HISTORIC AND DESIGN REVIEW COMMISSION

HDRC CASE NO: 2023-076
ADDRESS: 103 E HUISACHE AVE
LEGAL DESCRIPTION: NCB 1702 BLK 6 LOT 16 & 17
ZONING: R-4, H
CITY COUNCIL DIST.: 1
DISTRICT: Monte Vista Historic District
APPLICANT: Joseph Cotton
OWNER: Joseph Cotton/EDENS SWAIN M & MELODY M
TYPE OF WORK: Driveway modifications, Garage modifications
APPLICATION RECEIVED: February 08, 2023
60-DAY REVIEW: Not applicable due to City Council Emergency Orders
CASE MANAGER: Jessica Anderson

REQUEST:

1. Expand driveway and apron from 16' to 26' and expand the curb cut 10' to accommodate.
2. Modify a previously-approved design for an addition to the rear detached garage to include a third garage door.

**HOUSE & GUEST
HOUSE ROOF
PLAN / SITE
PLAN**

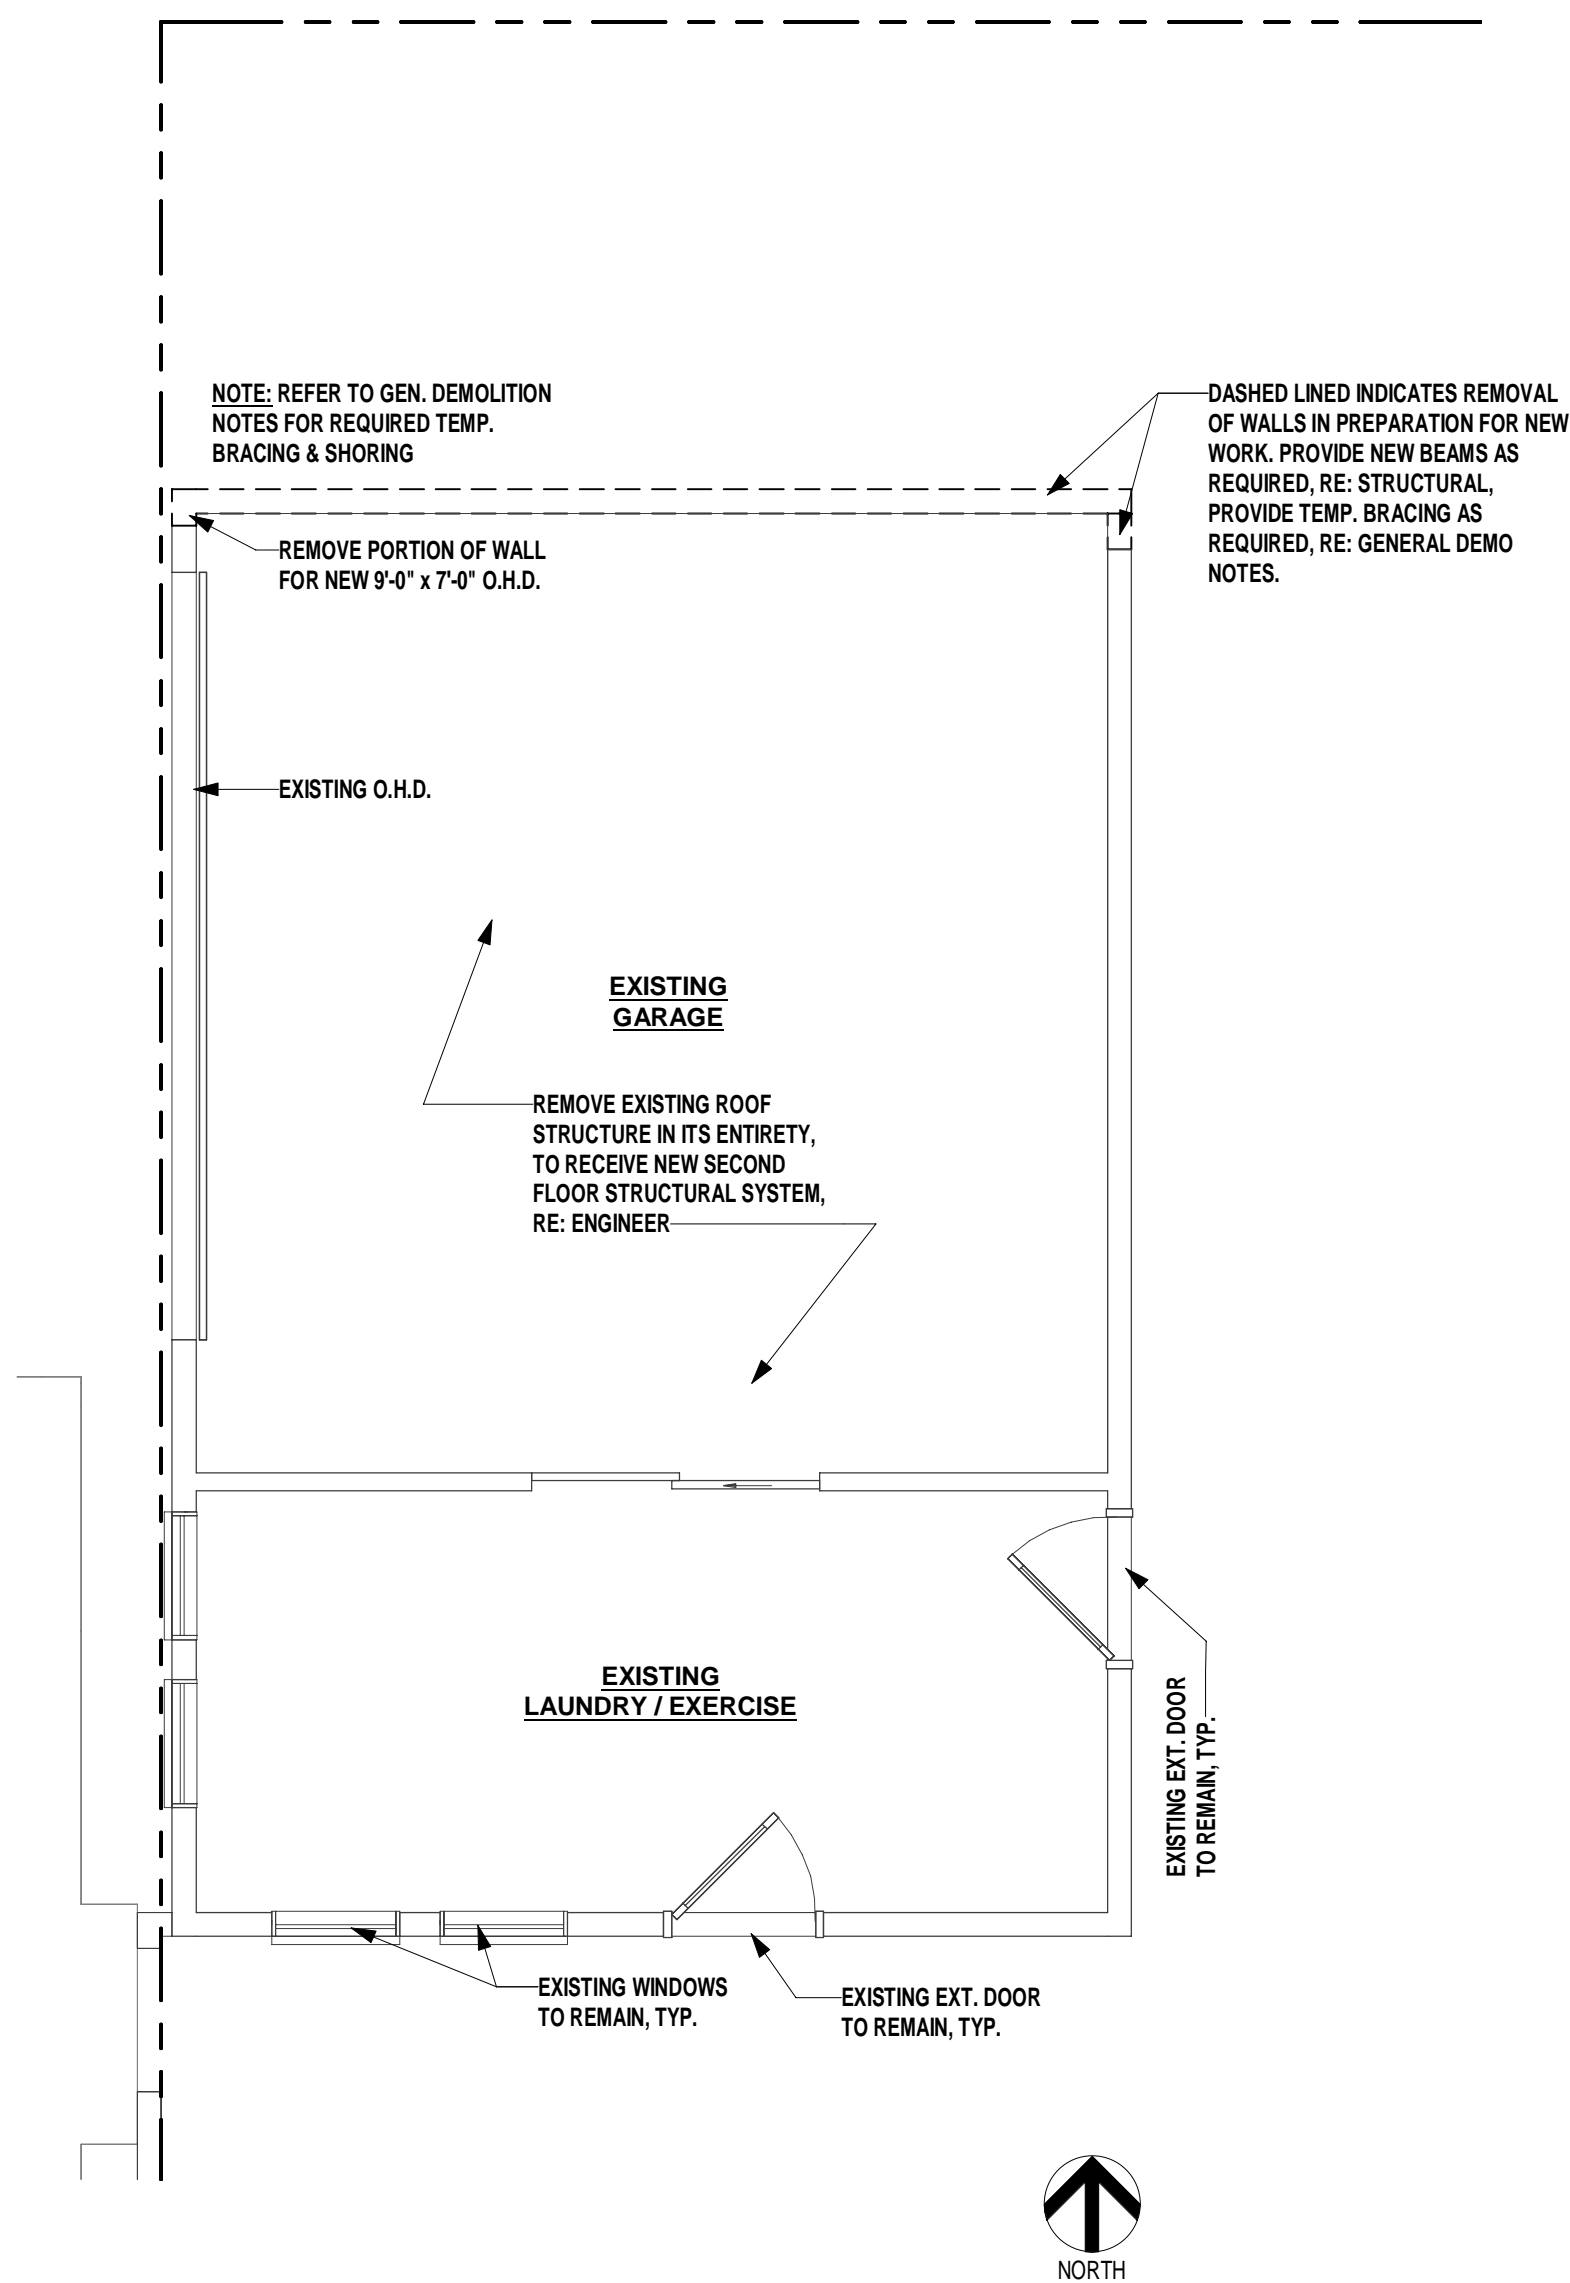
- c. DRIVEWAY AND CURB CUT: The applicant requests to expand the driveway, apron, and curb cut by 10'. Historic Design Guidelines for Site Elements 5.B.ii says to maintain the width and configuration of original curb cuts when replacing historic driveways, and avoid introducing new curb cuts where not historically found. Staff finds the proposed curb cut extension does not conform to guidelines.

Staff does not recommend approval of item 1, expanding the driveway and apron from 16' to 26' and expand the curb cut to accommodate, based on finding c.

- i. That the driveway and curb cut not be altered to accommodate the new garage door or that drivable pavers be introduced in front of the third bay in lieu of solid concrete.

GUEST HOUSE DEMO & NEW CONSTRUCTION FLOOR PLANS

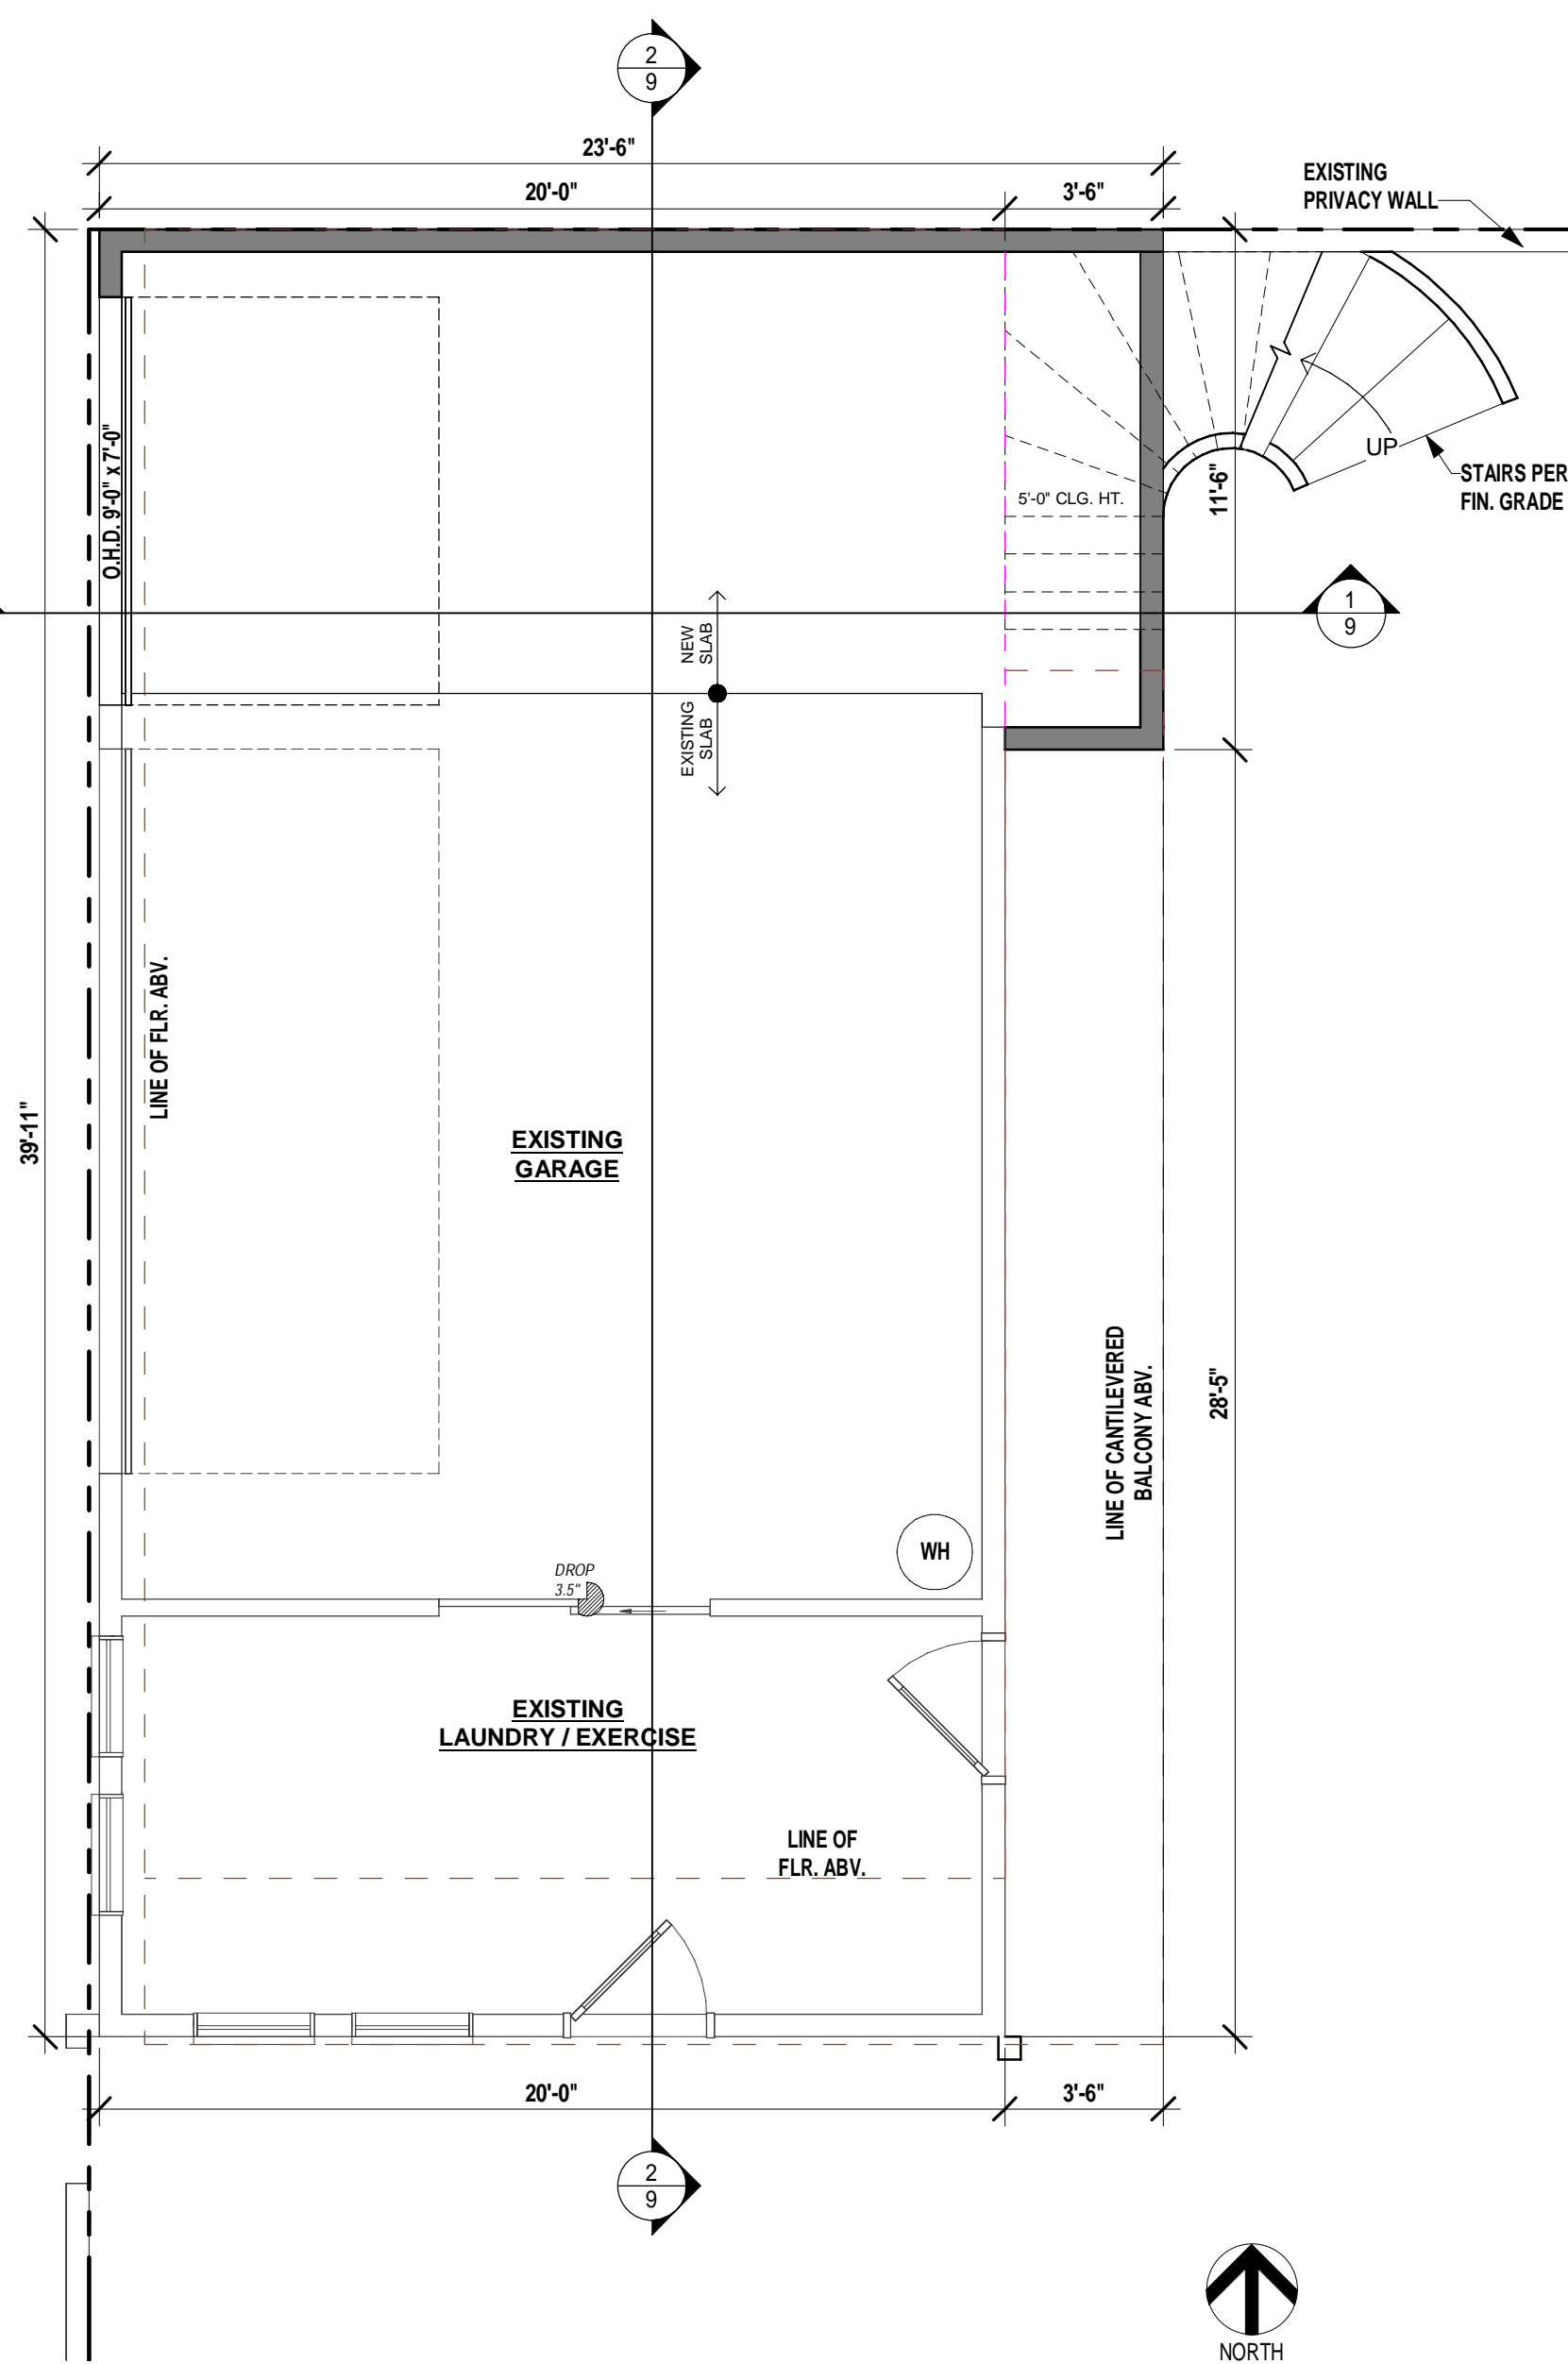
- d. GARAGE DOOR: The applicant requests to modify a previously-approved design for an addition to the rear detached garage to include a third single-bay garage door north of the existing two-car garage door, which is incorporated into the design. Staff finds the additional garage door generally appropriate, but that the driveway and curb cut should not be expanded to accommodate the new opening based on finding c.

The architectural prints shared as part of this request shows the addition of the proposed door on the "street side" and the stairwell on the interior side of the garage within view of the pool and general common area.

Staff recommends approval of item 2, modification of a previously-approved design for an addition to the rear detached garage to include a third garage door, based on finding d, with the following stipulation:
